**STATE FOREST HEADQUARTERS
OFFICE OF THE PRINCIPAL CHIEF CONSERVATOR OF FORESTS, ODISHA,
BHUBANESWAR**

No. **18581** /9F (MG) - 35/2021
Dated, Bhubaneswar the **03-11-2021**

Sub:- **Diversion of 349.709 ha. of forest land within total mining lease area of 2290.449 ha in Siarmal Open Cast Coal Mining Project by Mahanadi Coalfields Ltd. (MCL) in Sundargarh District, Odisha - Compliance regarding.**

Ref:- Govt. of India MoEF & CC, New Delhi Letter F.No.8-25/2021-FC dated 05.10.2021

Fig 01: DSS map of Satparlia RF identified for CA as on Dec'2019.

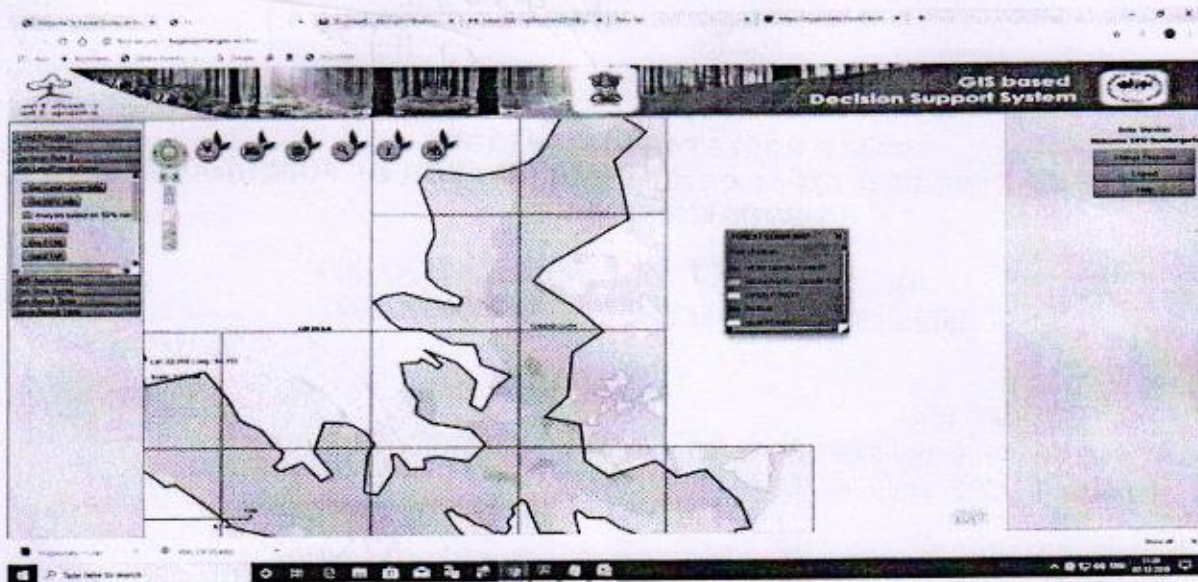
- 1) DSS analysis of the degraded forest land proposed for CA land revealed that out of total area of 712.477 ha proposed for CA, an area of 128 falls under MDF category, 556 under OF category, 1 ha under water body and 27 ha as non-wooded area. Suitability of 128 ha of degraded forest land revealed as MDF needs to be re-visited by the State.**

In compliance to the above, the RCCF, Rourkela Circle has reported that in Dec'2019, a patch of Satparlia RF was identified & demarcated after due DSS verification. A snapshot of the DSS map then taken, is as shown in Fig 01:-

Accordingly, the DFO, Sundargarh Forest Division has prepared the compensatory afforestation scheme over 581 ha excluding MDF area and water body. The CA Scheme has been prepared to take up ANR plantation @800 seedlings per ha over 581 ha which has been enclosed in the Diversion Proposal. Soil and moisture conservation will be taken up in MDF area.
